Revised March 2000. This bulletin supercedes the previous bulletin 2000-5. This bulletin was reprinted to improve the print quality of the art.

## Official Notification Under the U.S. Federal Boat Safety Act - Stainless Steel Electric Fuel Pumps

## Identification

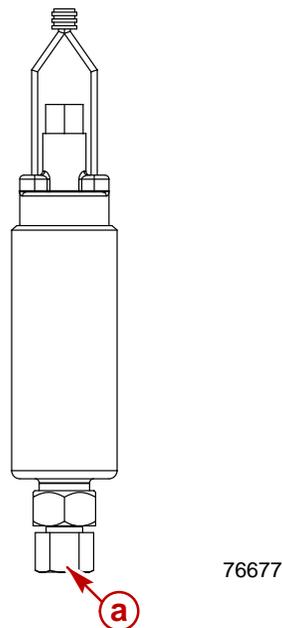
3. If the date code on the pump matches one of the date codes identified in item 2. above, then the inspection must continue.
  - a. **Carbureted models:** If the brass inlet fitting has a white marking on it, the pump was properly manufactured and does not need to be replaced; the inspection for that engine is over. Please notify Mercury MerCruiser as identified in item 4. below. If the pump does not have a white marking on the brass inlet fitting, it needs to be replaced with a new electric fuel pump. (P/N: **861155A 6**)

- b. **EFI/MPI models:** If the bronze outlet has a white marking on it, the pump was properly manufactured and does not need to be replaced; the inspection for that engine is over. Please notify Mercury MerCruiser as identified in item 4. below. If the pump does not have a white marking on the bronze outlet, it needs to be replaced with a new electric fuel pump. (P/N: **861156A 1**)

**a** - Position Of White Mark

Replace the electric fuel pump with a Quicksilver replacement fuel pump kit.

Carbureted engines: (1) 861155A 6

EFI/MPI engines: (1) 861156A 1
